Re: Wilderline to Duck River Pedestrian and Cyclist Paths

Thank you for the opportunity to comment on the proposal to construct new walking and cycling paths to connect the M4 shared path at Arthur St with the Clyde Station overbridge.

Figure 2:
City of Parramatta's Road User
Hierarchy (Source: Parramatta Bike Plan
2023)

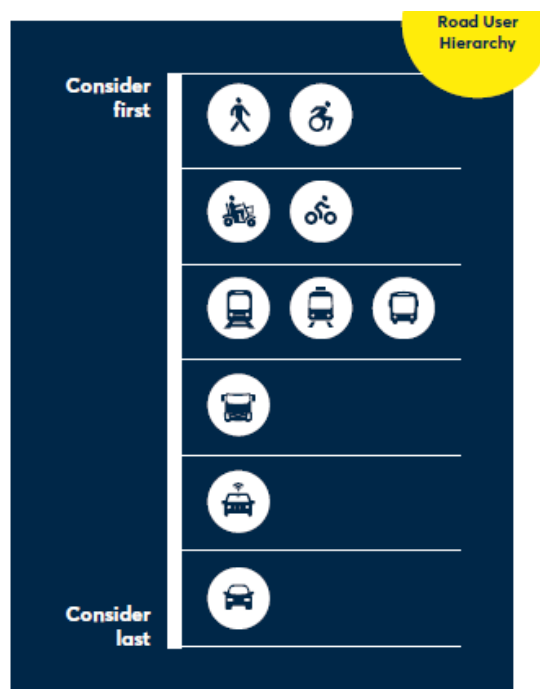
- Removing parking spaces to create space for walking and cycling infrastructure aligns with the Transport for NSW Road User Space Allocation Policy which prioritises people walking, then riding. Private vehicles should be considered last. The parking of private vehicles must no longer be the priority when allocating road space to different users. A Road User Hierarchy is now embedded in Parramatta's Bike Plan 2023 (Figure 2). Council has committed to apply the hierarchy in road space allocation and transport investment decisions.
